BUILDING PERMIT REPORT

DATE: 3 July 2000 ADDRESS: 86 Patridge Circle CBL: 228A-A-008

REASON FOR PERMIT: Enlarge existing deck

# Campbell Deck Layout

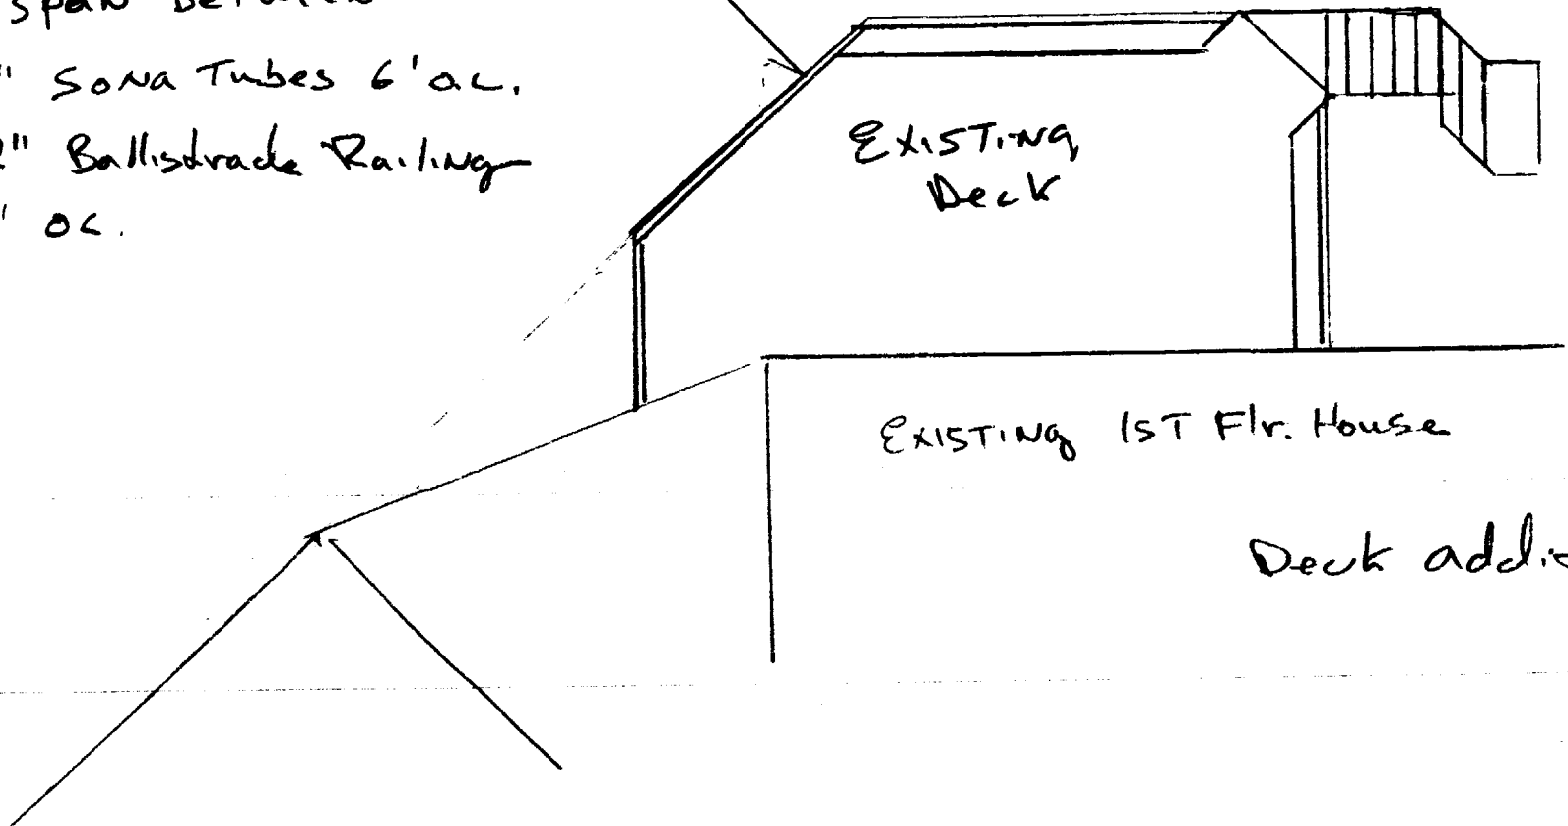
- (31) Please read and implement the attached Land Use Zoning report requirements. *This Deck shall not be closer than 25 feet to the rear property line.*

- \*36. *See attached details on stairs and guardrails and handrails.*
- \*37. *The prepared piers for foundation shall be a minimum of 4' below grade (on bedrock) on footing with fasteners between footing, pier and pier and deck framing.*

25' Property Line  
other plan shows 26' set back line
